Reliable Electronic Solutions

## Bourns® Trimpot® Division Announces 3214/3224 Product Update

Figure 1: BdeM (Mexico) Video Jet vs. Laser Marking

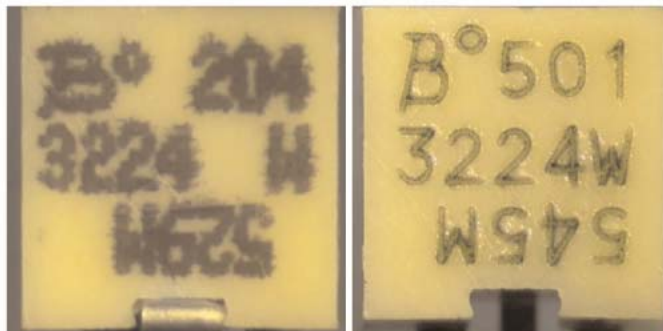
Bourns is pleased to announce a product update to Models 3214W/3224W. Effective with date codes 549M and 550C, respectively, a new laser-marking scheme will be phased-in to our manufacturing process. The new laser marking meets all industry-processing guidelines and is environmentally friendly. Other pad layouts on Models 3214X, G, J/3224X, G, J will implement the new laser marking in late January or early February.

During the transition period, both types of marking may be included in the same embossed tape carrier package. Below are pictures of the video ink jet and laser marked units from Mexico and Costa Rica. There is no change in the form, fit or function of the product.
